ADDENDUM NO.1

FOR  
REPLACE IIT CONFERENCE CENTER ROOM DIVIDERS  
DANIEL K. INOUE INTERNATIONAL AIRPORT  
HONOLULU, OAHU, HAWAII

STATE PROJECT NO. CO1342-43

JUNE 5, 2023

DRAWINGS A

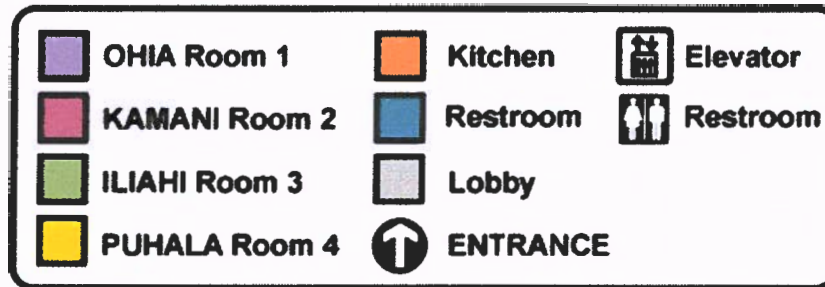
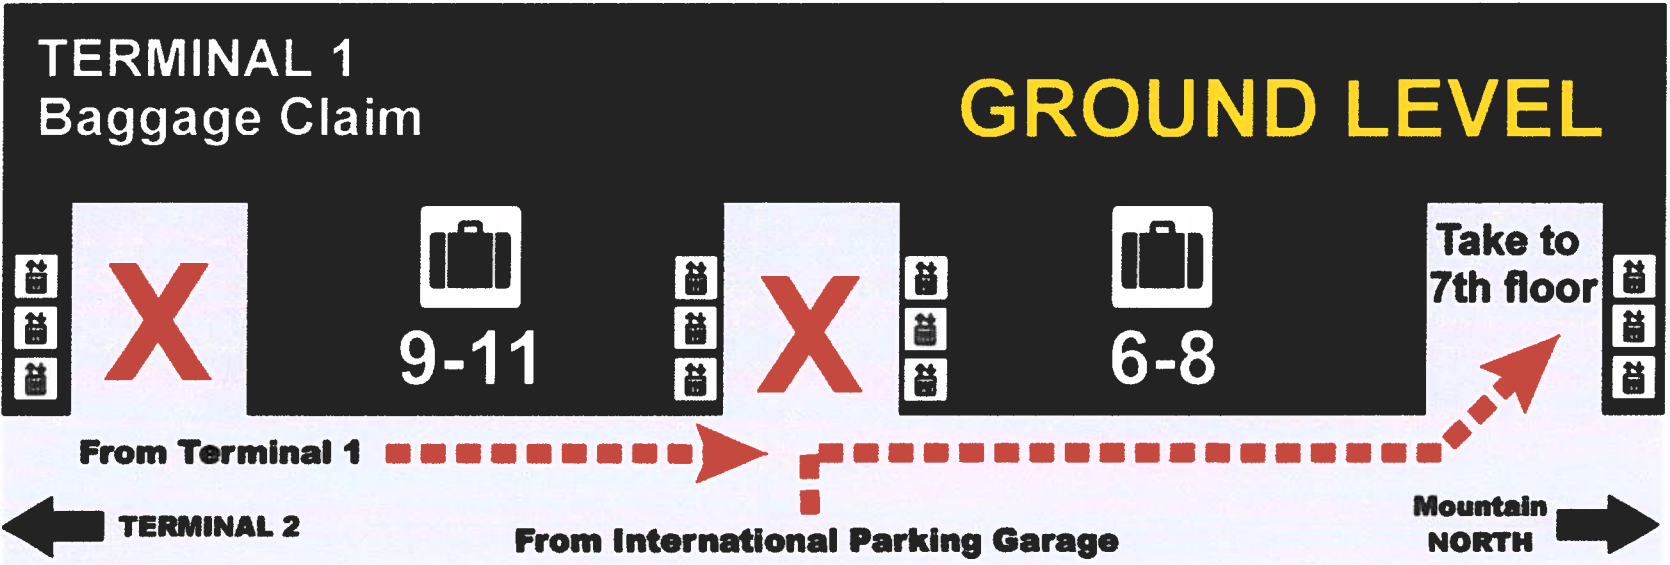
6. **Please provide site map of the building in relation to Daniel K. Inouye International Airport.**

*Response:* Site map of the building is provided via this Addendum.
